Date: November 14, 2023

Author and title: Yumie Dahn, Senior Planner

Title: Tahoe Donner Downhill Ski Lodge Appeal (Planning Application 2023-00000158/APL)

Figure 6: Grading Section A-A, existing and proposed

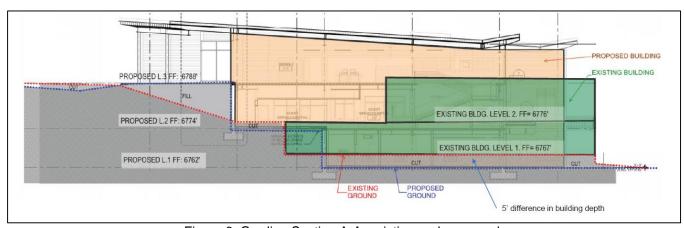
Comment #13: The second and fourth paragraphs on page 3 present an argument that reducing the length of the proposed project retaining wall foundation drain versus existing conditions would result in a reduced volume of water requiring drainage. This may be the case if the base of the foundation drains were located at the same elevation or depth below groundwater. However, Master Response 1 presents an invalid comparison as it does not account for the different base elevations of the existing and future foundation drains. The foundation elevation associated with the proposed Level 1 building will be at 6762 feet resulting in an associated foundation drain elevation around 5-feet lower (or 5 feet deeper) than the existing conditions drain elevation. This will lead to the proposed project foundation drain being submerged 5 feet deeper under groundwater, resulting in a longer period of being submerged and a greater volume of water discharge to the drainage swale versus a drain constructed at the existing condition elevation. The MND has not adequately quantified the discharge volume of either existing or future project condition foundation drains needed to evaluate the potential impact to the environment and should be considered incomplete. It is my professional opinion that such calculations are reasonably feasible using standard industry accepted methods but are lacking from the MND.

Although the cut of the proposed project foundation is approximately five feet greater in depth than the existing building (see the blue line compared to the red line in Figure 6), the footprint of the proposed building (4,420 s.f.) on the site is 47.5% (or less than half) of the size of the existing footprint (9,300 s.f.) (see Figure 7).

Regardless, conveyance of groundwater with foundation drains to appropriately designed safe release locations on a permanently developed site are allowed, and an exempt activity, under the State's stormwater requirements. So long as the safe release outlet locations of the foundation drains are designed to accommodate the maximum flow rate of the size of the foundation drainpipes, and that the foundation drains and outlet have appropriate sediment control methods, this proposed scenario would meet State and local requirements.

Given the perched nature of the groundwater regime it is speculative to assume that TDA can calculate how much of the foundation drains is going to be exposed to groundwater under all potential groundwater conditions. Foundation drain discharge currently occurs on this site and will continue to occur under the proposed conditions.

During seasonal high groundwater conditions, the existing condition foundation drain discharge and the proposed foundation drain discharge will be substantially similar and will be on the order of 2 gallons per minute (GPM) to 20 GPM. As the groundwater table stabilizes throughout the dry season it is possible that the proposed foundation drain system may discharge more than the existing conditions on the order of .4 to 4.2 GPM. However, this minor increased foundation drain discharge does not pose a hydrology or water quality impact as described on page 52 of the MND. In other words, an increase in discharge rate is not a per se water quality impact without evidence of sedimentation, pollution or flooding.
